Part 21 (PAR)

Event # 51976

PART 21 - NOTIFICATION OF DEVIATION OF K-LINE CIRCUIT BREAKER SECONDARY TRIP LATCH

Subject: 10CFR Part 21 Notification of Deviation re. K-Line Circuit Breaker Secondary Trip Latch

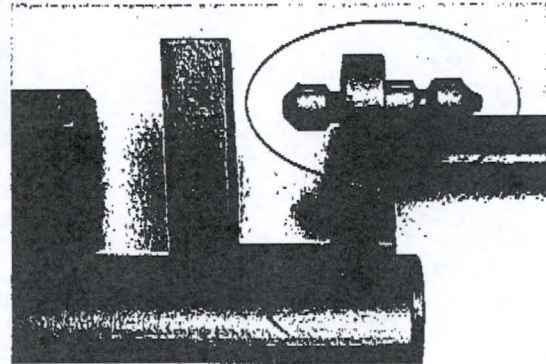
The pin that holds the return spring in place was not properly installed. The defect is believed to have occurred during the assembly process of the latch bar. The latch used in the Prairie Island Nuclear Plant circuit breaker was fabricated in 2013. Please see the photos below for an illustration of the correct, and incorrect, configuration of the pin installed in the secondary trip latch.

Correct – pin is centered

Incorrect – pin is not centered

- a. Quarantined and inspected P/N: 716789E00 and 167710T01/167710T03 assemblies in inventory. (Action complete)
- b. Notified vendor of the issue via the ABB Supplier Corrective Action Request process. (Action complete)
- c. Revised Critical Characteristic card for P/N: 716789E00 to incorporate measurement of the pin in question. (Action complete)
- d. Conducted training with QA and Operations personnel for awareness (Action complete)

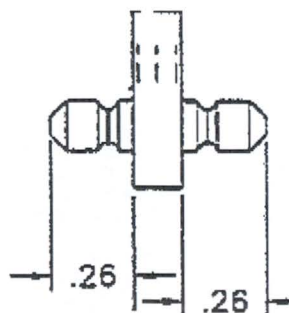
The pin should protrude 0.26 (+/- 0.02) inches out of both sides of the section of the latch bar assembly. Please see the diagram below for a visual representation.

If the latch is installed on a K-Line circuit breaker, the latch can be inspected from the bottom side of the mechanism without disassembly.
